Stage 1 Road Safety Audit

Gort Town Centre Public Realm Scheme

On behalf of **Galway County Council**

3.2.2 Pedestrian Connectivity Lowry's Lane to Town Core

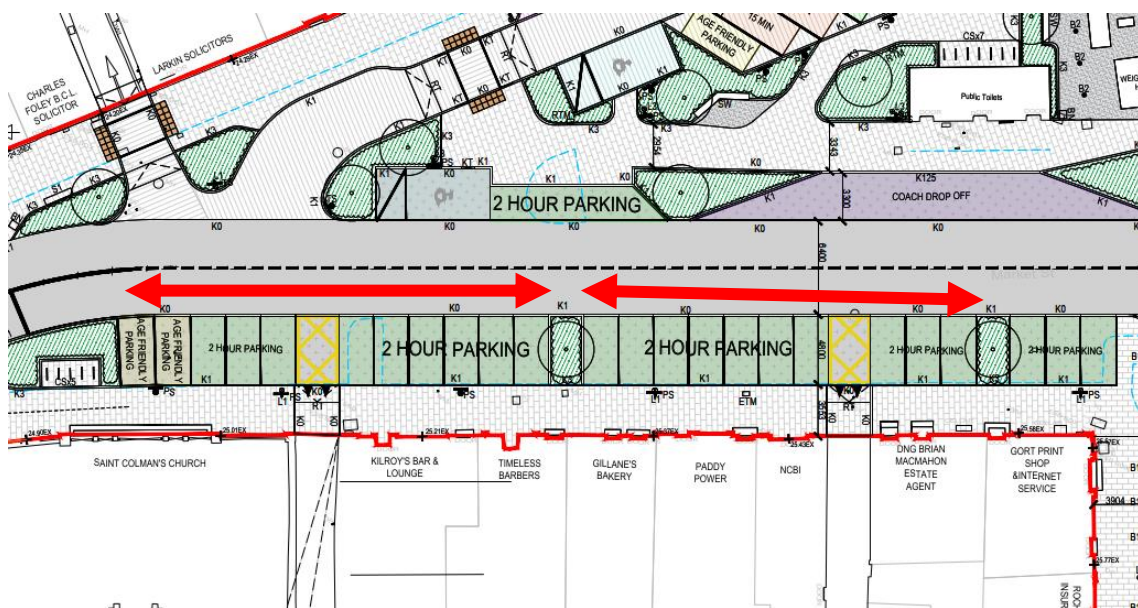
Problem: There is a large car park proposed for Lowry's Lane. The likely desire line for pedestrians from this car park is to walk along Lowry's Lane into Market Street and across to the town core. The pedestrian crossings of Market Street are to both ends, which requires a diversion off the likely desire line. Pedestrians are likely to cross Market Street as a continuation of, or close to, Lowry's Lane.

Hazard: No assistance for sight impaired pedestrians attempting to cross the road in this location is given. The sight impaired pedestrian may errantly enter the carriageway, into the path of oncoming traffic.

Recommendation: The Design Team should provide an uncontrolled crossing closer to the likely pedestrian desire line.

3.2.2	Yes	No	We will provide a raised crossing as a shared space to enable access to the main square and traffic calming along Market Street	Yes
3.2.3	Yes	Yes

3.2.4 Vehicular Footpath Crossovers

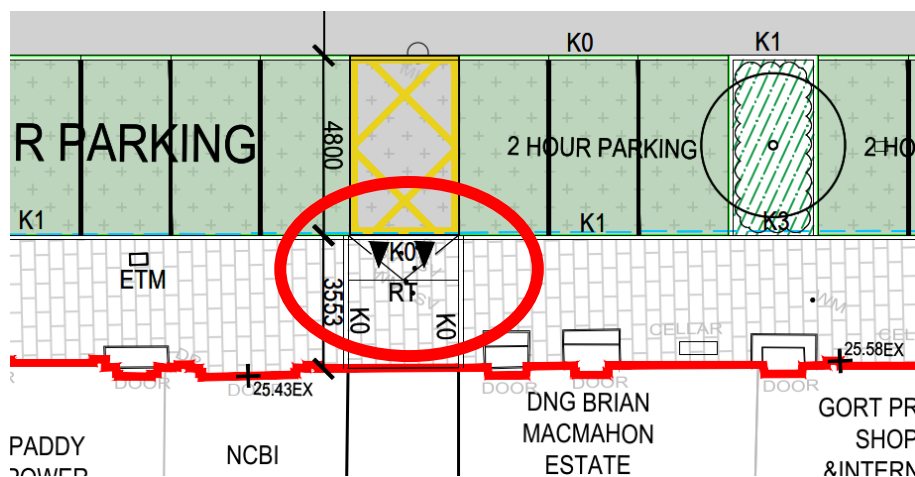
Problem: There are a number of locations where vehicles are permitted to cross the footpath in order to access driveways and back lands. At these locations a flush kerb is indicated to the rear of the car parking bay adjacent to a 100mm face kerb. It appears there is a ramp up from the car park level to the footpath level incorporated into the footpath. There are two problems with this arrangement.

1. Pedestrians walking along the line of the footpath may trip on the side of the ramp.
2. Sight impaired users may errantly depart the footpath where there is zero kerb face and walk within the car parking bays / carriageway.

Recommendation: Omit any trip hazards within the footpath and also retain a minimum 60mm kerb face between the footpath and the car parking bay / carriageway.

3.2.4	Yes	No	This is a tried and tested detail which allows a continuous footpath level for a minimum of 2m against the building edge and then a sloped section for cars to mount. This detail ensures that there are not excessive slopes across the whole footpath and towards the channel line of the road. The paving will also be contrasting colour to demarcate this as a driveway crossover.	Yes

3.2.5 Driveway Visibility

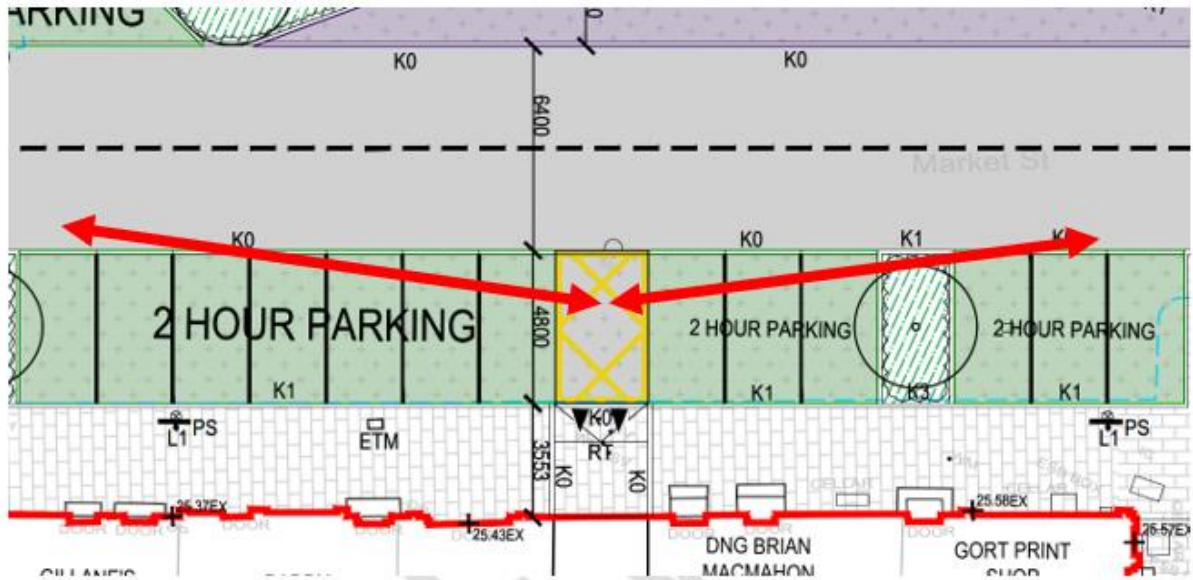
Problem: There are a number of locations where vehicles are permitted to cross the footpath in order to access driveways and back lands in between roadside parking bays. Visibility may be restricted by high sided vehicles in the parking bay.

Hazard: Motorists may proceed into the path of oncoming traffic.

Recommendation: Ensure adequate visibility is provided for all users entering the public carriageway.

3.2.5	Yes	No	This is typical and an existing scenario within the town where there is on street parking and entrances to driveways / alleyways. Its not feasible to take out all of the parking on the streets, instead the yellow markings provide a clear space for vehicles to enter an exit. There is very low number of vehicles doing this movement.	Yes. However, it is suggested the landscaping within the bay is located to the approaching traffic side of the entrance, to provide some visibility.

3.2.6 Pedestrian Crossings – Visibility

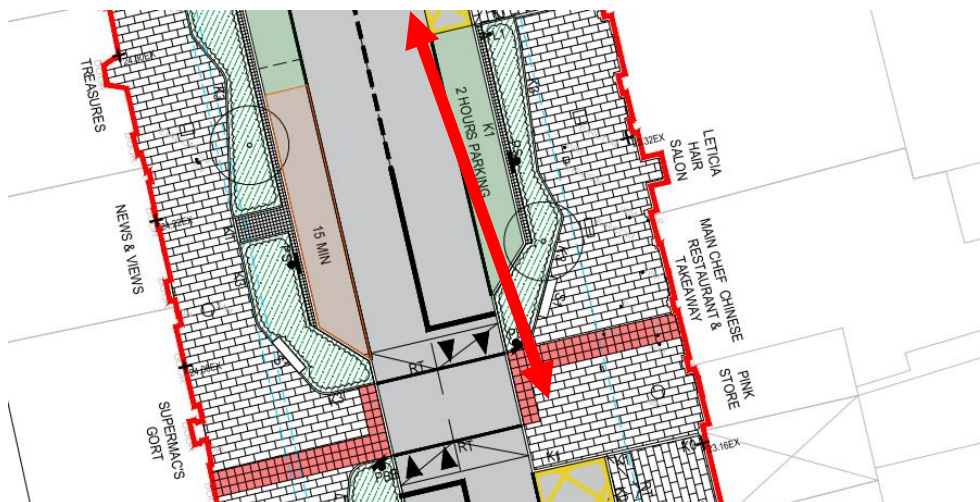
Problem: Visibility to pedestrians waiting to cross the road may be restricted by high sided vehicles parked in adjacent parking bays and/or high vegetation. This problem includes signal-controlled crossing locations, as pedestrians often cross the carriageway even when shown a red man at the light.

Hazard: Pedestrian may step out into the path of oncoming traffic.

Recommendation: the Design Team should ensure adequate visibility is provided. This should include pedestrians waiting to the rear of push chairs at the carriageway edge.

3.2.6	No	Yes	Across the town we have designed lots of crossings with a set back before the parking spaces are created. The crossing in this case is raised to further calm traffic and the crossing is built out the channel line to maximise visibility. All planting next to crossings will be maintained to a maximum 600mm high

3.2.7 Sharp Kerb Edges

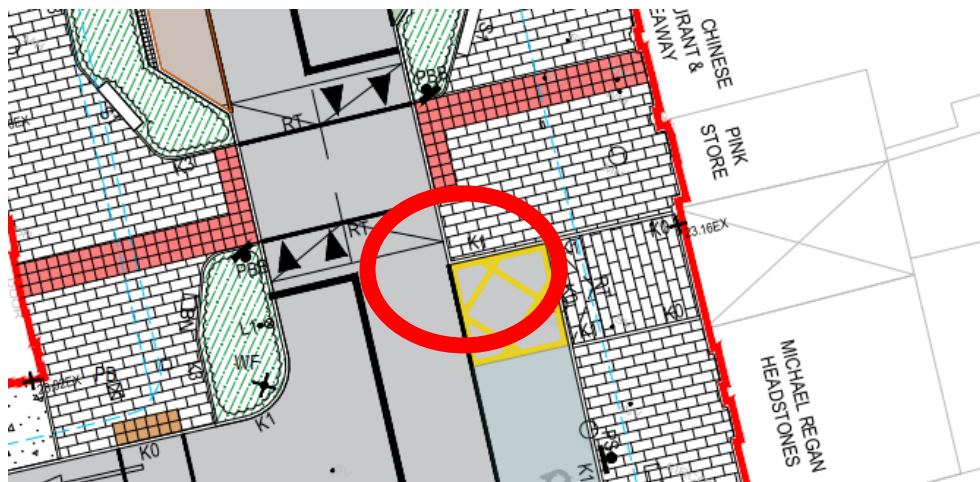
Problem: There are areas within the design that indicate a 100mm high kerb meeting at a 90 degree corner. Vehicles that attempt to turn at these locations are at risk of tyre damage on the kerb.

Hazard: Tyre damage caused at these locations may result in tyre failure elsewhere on high-speed roads.

Recommendation: The Design Team should design out areas of potential vehicle tyre damage.

3.2.7	No	Yes	All 90 degree kerbs will be a smooth radius quadrant kerb with a bull nose top	
3.2.8	Yes	Yes		
3.2.9	Yes	No	A paved margin will be provided adjacent to the kerb to assist connectivity for all vehicle passengers	Yes

3.2.8 Disabled User Parking Bays – Church Street and Market Street

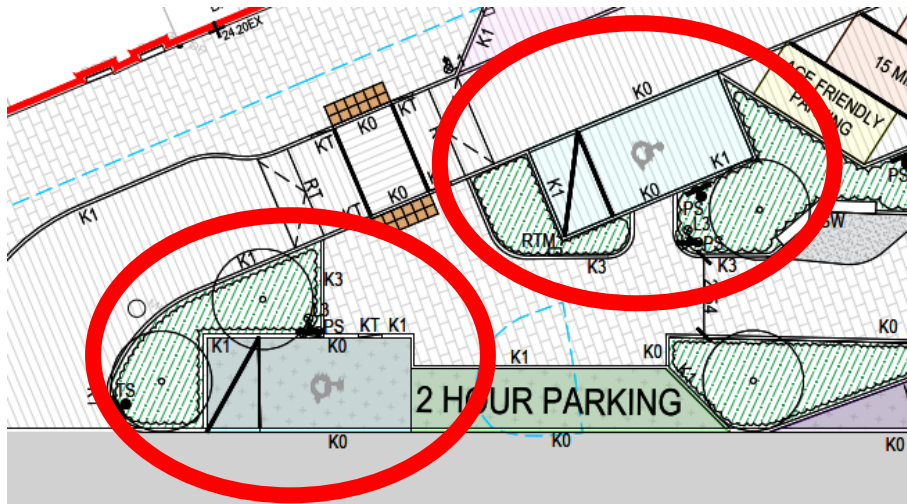
Problem: There are a number of disabled user parking bays located throughout the scheme. Some of these bays have landscaping located between the bay and the footpath. Users with differing disabilities use different methods of accessing / egressing their vehicles. This can include rear door access, rear side doors or front doors.

Hazard: Disabled users without direct access to the footpath may be required to travel on the carriageway prior to accessing the footpath. Impact from passing vehicles may result.

Recommendation: The Design Team should ensure direct access to the footpath can be achieved from all the vehicle passenger doors.

3.2.9 Landscaping Adjacent to Parking Bays

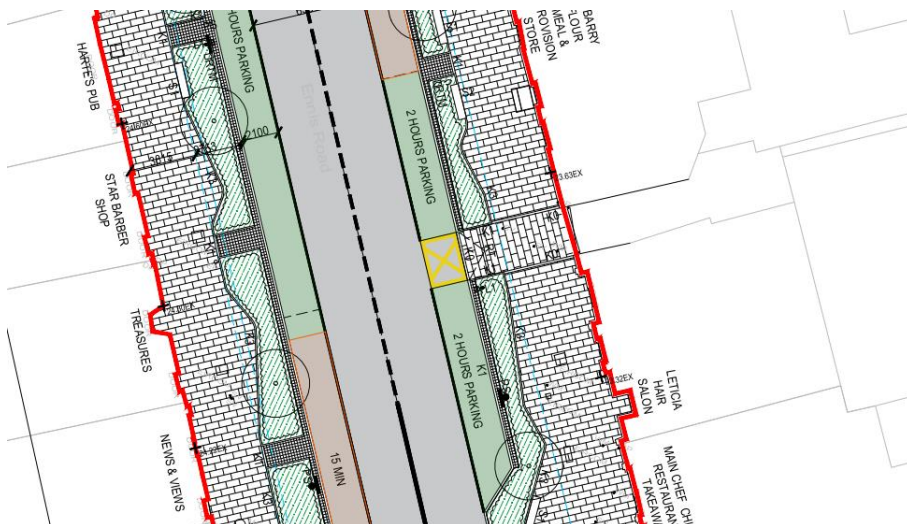
Problem: There are lengths of linear landscaping strips located adjacent to on-line parking bays. Although there are a number of paved links from the footpath at the rear of the landscaping through to the parking bay, these links will only be of use if the parked vehicle directly aligns with the paved link and even then, they will only be of use for the passenger adjacent to this link.

Hazard: Vehicle drivers and passengers are likely to walk within the carriageway until they can find a paved link through to the footpath. This may involve walking the full length of the parking bay on the carriageway. Impact from passing traffic may result.

Recommendation: The Design Team should omit the landscaping and provide direct connectivity to the footpath for all vehicle passengers.

3.2.10 Coach Drop-off Bay

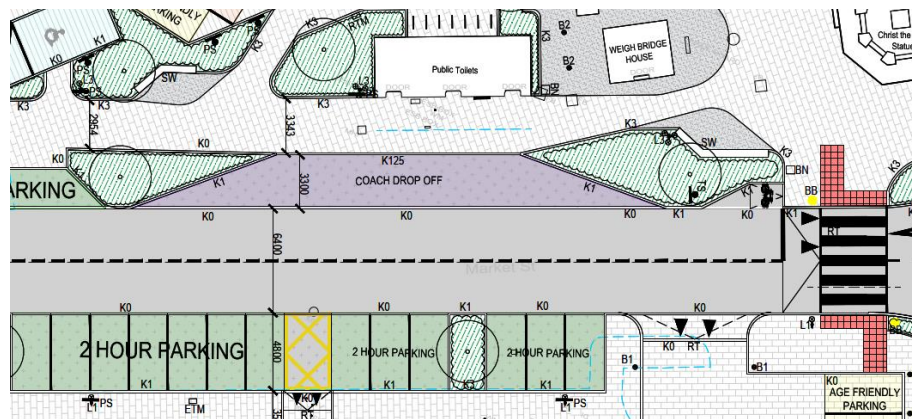
Problem: The coach drop-off bay is located on the northern side of Church Street. No information has been provided by the Design Team to the route of the coach. There is concern the coach may arrive from the M18/R458. If this is the case the coach will need to turn on or near to Church Street in order for the passenger door to be adjacent to the footpath, or passengers will alight into the carriageway. There is no obvious location for the coach to undertake a 'U' turn along Church Street.

Hazard: The coach may attempt to reverse into one of the side streets off Church Street. Impact with other road users may result. If passengers alight into the carriageway, impact from passing traffic may result.

Recommendation: The Design Team should ensure the coach arrives from Church Street west and does not need to undertake a 'U' turn in order to achieve a drop off or collection.

3.2.10	No	Yes	The coach will have a set route and will not turn in side streets	
3.2.11	Yes	Yes		
3.3.1	Yes	No	Options are being considered to provide necessary vehicular access to Lowrys Lane from the new off street car park, to omit the need for vehicles to use this link	No. The outcome of these "considerations" may be to maintain vehicular use of the link.

3.2.11 Church Street – Perpendicular Parking Bays

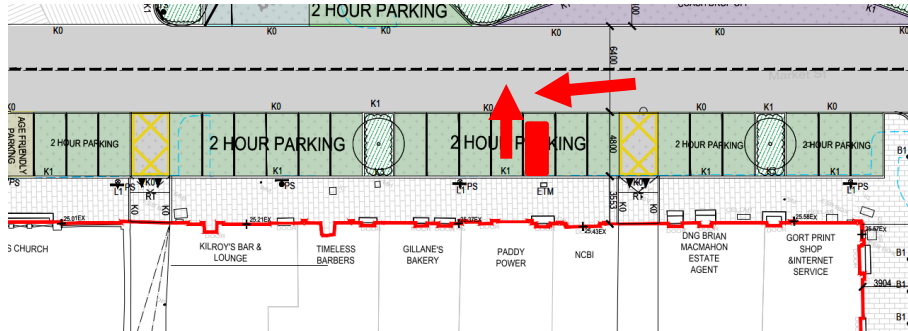
Problem: There is a long run of perpendicular parking bays on Church Street. Users attempting to exit these bays may have visibility to oncoming traffic restricted by adjacent parked high-sided vehicles.

Hazard: Exiting motorists may be struck by passing mainline traffic.

Recommendation: The Design Team should provide a buffer strip between the carriageway and parking bay, such that mainline traffic can observe a moving vehicle and slow/stop to permit this vehicle safe egress.

3.3.1 Crowe Street Car Park – Pedestrian Access

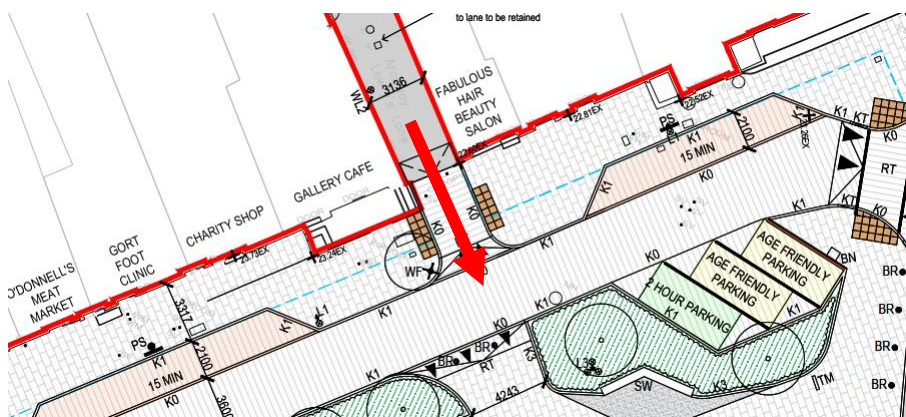
Problem: It appears from the drawings that pedestrian access to/from the car park is intended to be achieved via Lowry's Lane. This lane is very narrow and currently used by vehicles to access the rear of premises.

Hazard: Motor vehicles are unlikely to have sufficient room to pass wheelchair users. The motorist may decide to reverse back onto Market Street. Impact with pedestrians on Market Street may result.

Recommendation: Prohibit vehicular use of the lane.

3.3.6 Crowe Street – Widening (2)

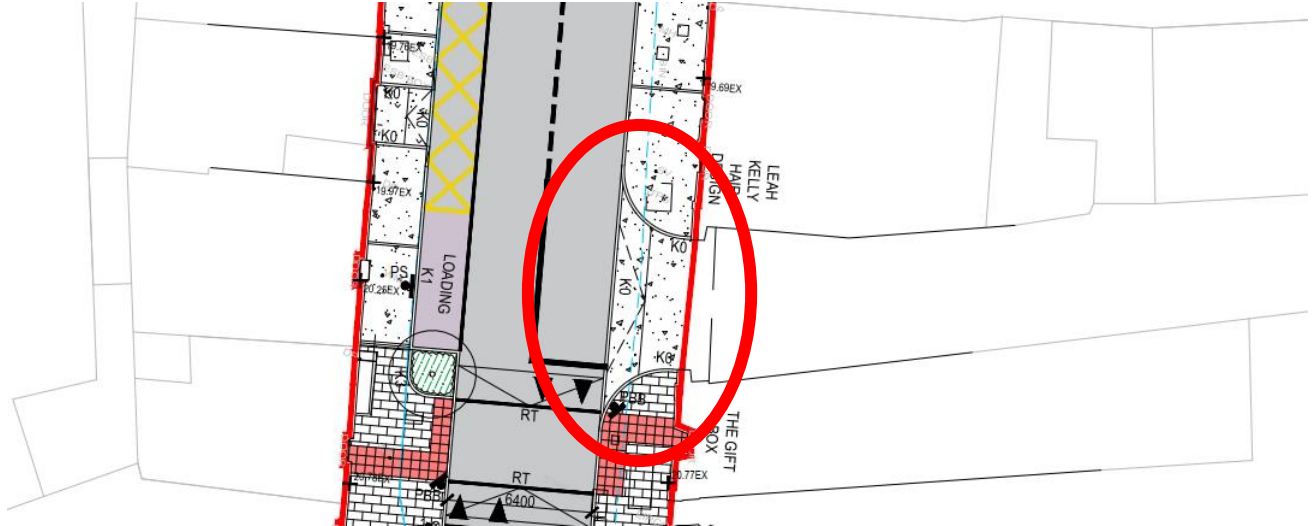
Problem: Two separate sections of carriageway widening are proposed on Crowe Street for passing of opposing vehicles. There is concern the widenings will be used for vehicle parking and serve to further reduce the available carriageway width.

Hazard: Head-on impacts from opposing vehicles may result.

Recommendation: The Design Team should ensure the passing bays are kept clear of parking vehicles.

3.3.9 Church Street – Zebra Crossing near Garraghbeg Road

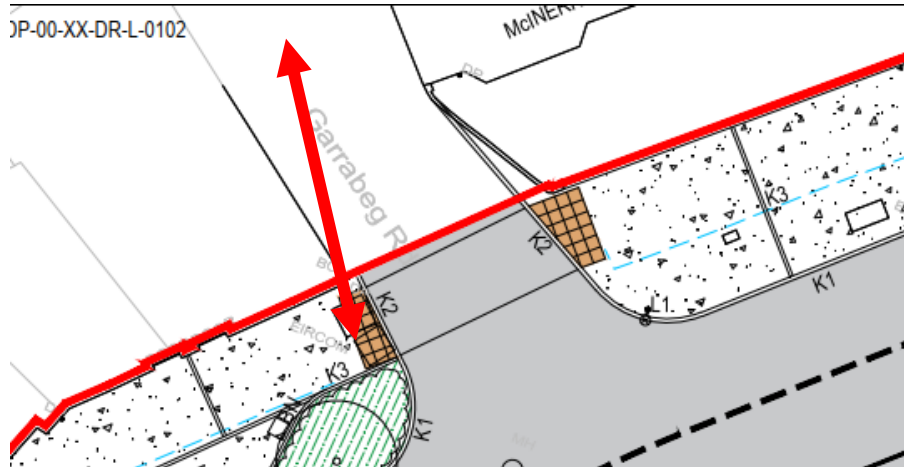
Problem: There is a zebra crossing proposed to the south of Garraghbeg Road junction. This zebra crossing is located on a bend with both landscaping and vehicles parking to both sides. Pedestrians waiting to cross the road may be shielded from view by either/or the landscaping or parked high sided vehicles.

Hazard: Pedestrians may commence their crossing into the path of unsighted vehicles.

Recommendation: The Design Team should ensure all visibility splays are clear of obstruction.

3.3.2	Yes	Yes		
3.3.3	Yes	Yes		
3.3.4	Yes	Yes		
3.3.5	Yes	Yes		
3.3.6	Yes	Yes		
3.3.7	Yes	Yes		
3.3.8	Yes	Yes		
3.3.9	No	Yes	We have carefully located the crossing at this location to ensure the best possible visibility given the bend in the road. In addition this crossing is a raised table. All vegetation will be ground cover to ensure visibility

3.3.11 Church Street – McNerney Auctioneers and Dwelling House

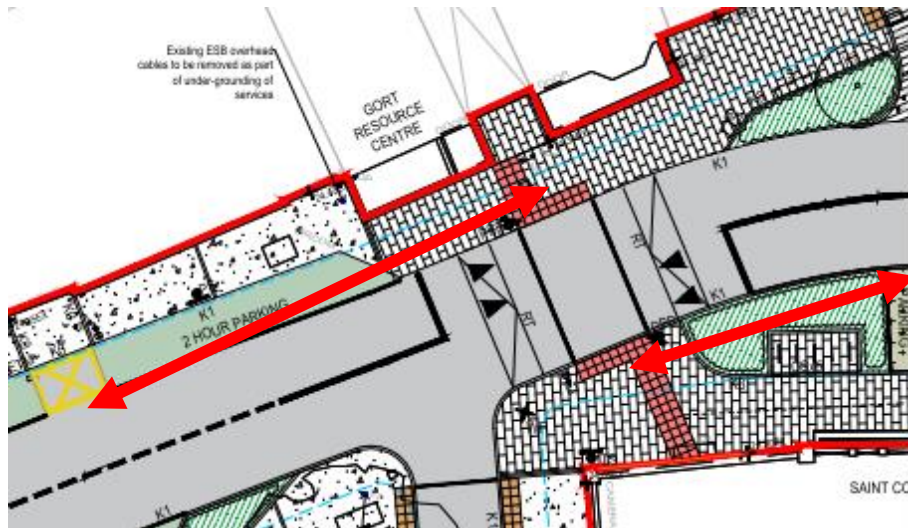
Problem: There is existing off-street parking located at McNerney Auctioneers and a dwelling house at the corner of the Gort Family Practice. The proposals include for the provision of a 100mm high kerb across both entrances and also a parking bay.

Hazard: Riders of powered two-wheeled vehicles may lose vehicle control when attempting to cross the kerb. Additionally high sided vehicles in the parking bay may restrict visibility on exit from the driveways.

Recommendation: The Design Team should provide suitable entrance to the parking areas, with suitable visibility splays.

3.3.13 Barrack Street – Controlled Crossing at R458 Junction.

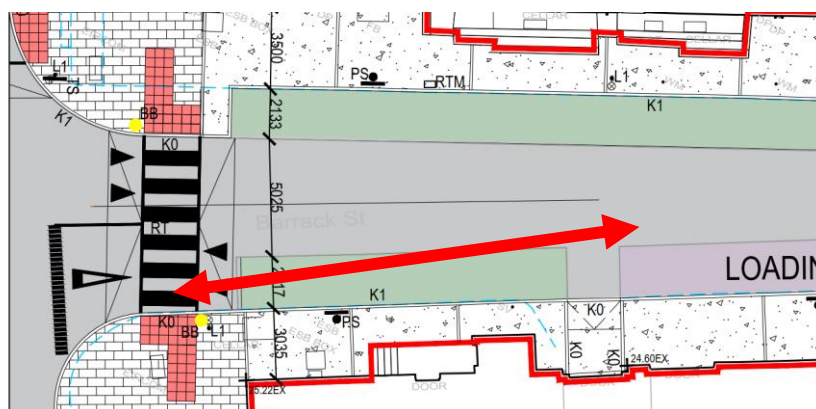
Problem: There is a parking bay located to the east of the controlled crossing. High sided vehicles within the parking bay may restrict driver visibility to the waiting or northbound crossing pedestrian.

Hazard: Pedestrians may commence their crossing unsighted to oncoming motorists.

Recommendation: The Design Team should reduce the carriageway width at the mouth of the junction such that the southern side of the crossing is visible to approaching motorists.

3.3.10	Yes	Yes		
3.3.11	Yes	Yes		
3.3.12	Yes	Yes		
3.3.13	Yes	No	Currently large vehicles reverse down Barrack Street. We have designed the ability for them to drive down the street and turn	No. If the carriageway width must remain, the

3.3.14 Coach Parking Near Christ the King Statue.

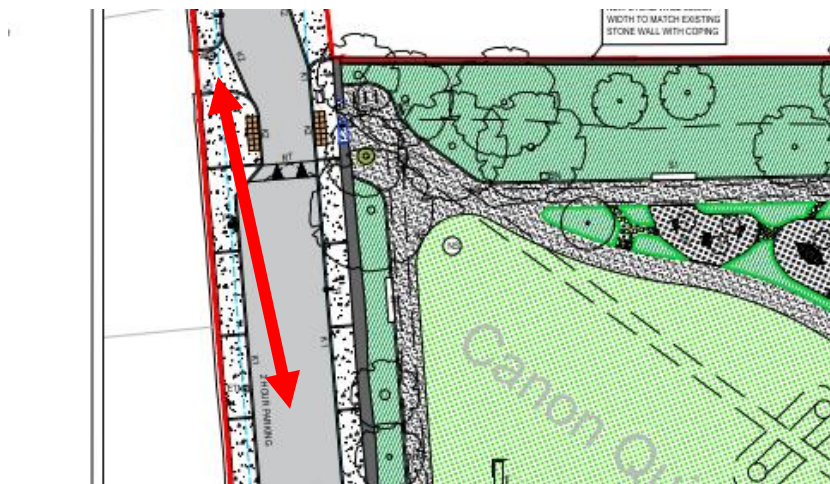
Problem: The coach parking is indicated with a K100 kerb adjacent. Some users may have difficulty in stepping from the kerb up onto the bus.

Hazard: Trip/fall incidents may result.

Recommendation: The Design Team should replace the K100 kerb with a Bus Kerb.

3.3.16 Queens Street – Bus Parking

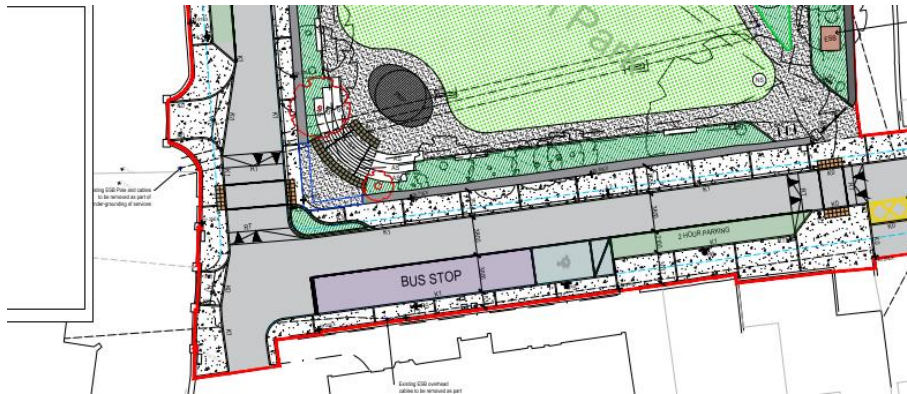
Problem: It appears the design is reducing the carriageway width on elements of Queens Street. There is a bus stop located on Queens Street. There is concern that the general reduction of carriageway width will result in difficulties for the bus to navigate along and around the tight bend in Queens Street. The bus may be required to reverse or over-run the footpath.

Hazard: The bus may impact with other vehicles or pedestrians.

Recommendation: The Design Team should ensure adequate carriageway space is provide for the bus to travel without the need to reverse or overhang the footpath.

3.3.17 Georges Street – Pedestrian Cross Outside Supermac's

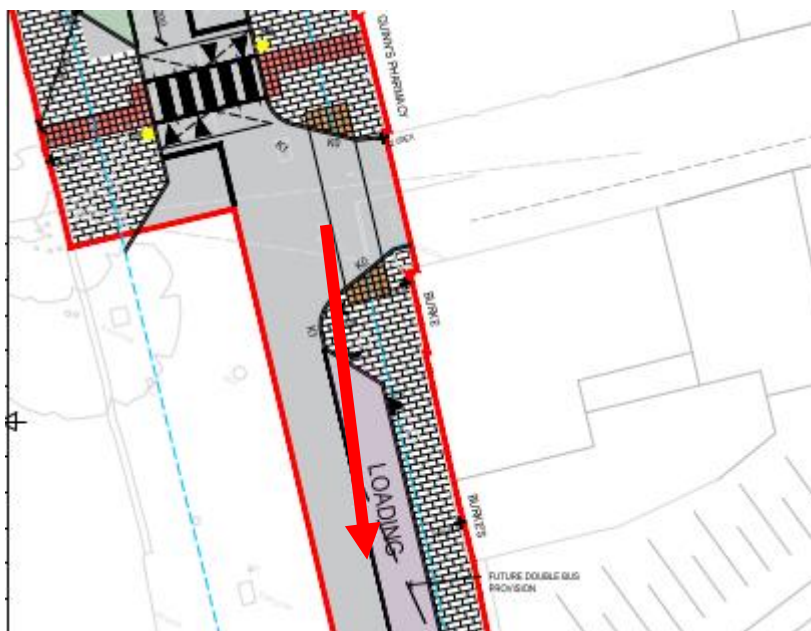
Problem: There is a pedestrian crossing proposed on Georges Street, outside of the Supermac's premises. Currently there is a double kerb in this location as the carriageway is substantially lower than the footpath. There is concern that the footpath to the crossing will be excessively steep.

Hazard: Mobility-impaired users may fall due to the gradient.

Recommendation: The Design Team should ensure all footpath gradients comply with current best practice.
